DO NOT ADJUST THE DIMENSION FROM THE DRAWING			
	NAME	SIGNATURE	DATE
DRAWN BY	M.KARADELI		10.09.96
CHECKED	M.KARADELI		10.09.96
APPROVED	C.GÜLERYÖZ		10.09.96
SCALE	Item Name:		
-	17.5x6.00

DRAWING NO
600101

This rim has all specifications of E.T.R.T.O. and DIN 78022

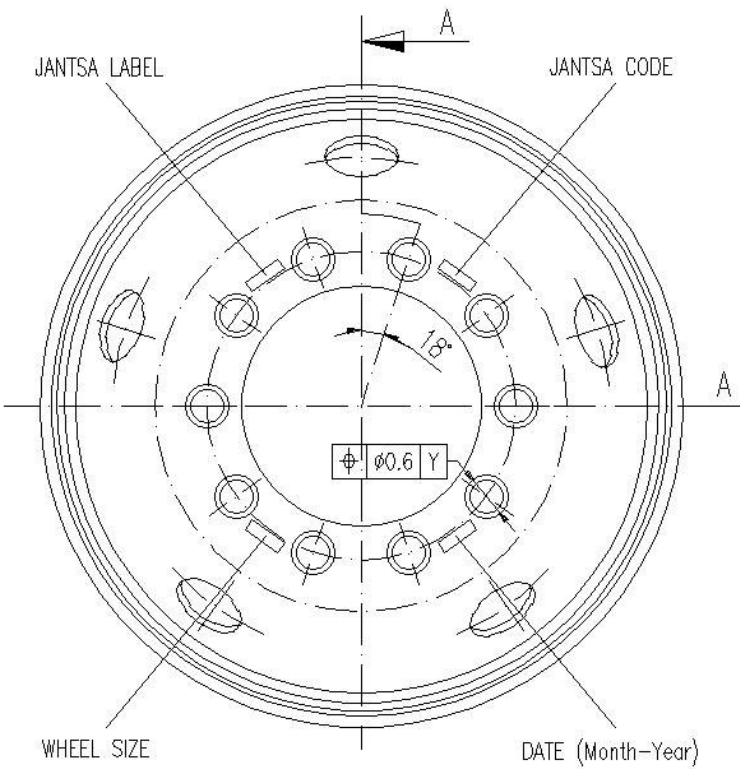
LETTER	DESCRIPTION	REVISION	DATE	REV.NO
Ⓐ	Bore hole diameter tolerance is changed. Before +1 Now +0.2	Drawing is changed.	09.09.04	1
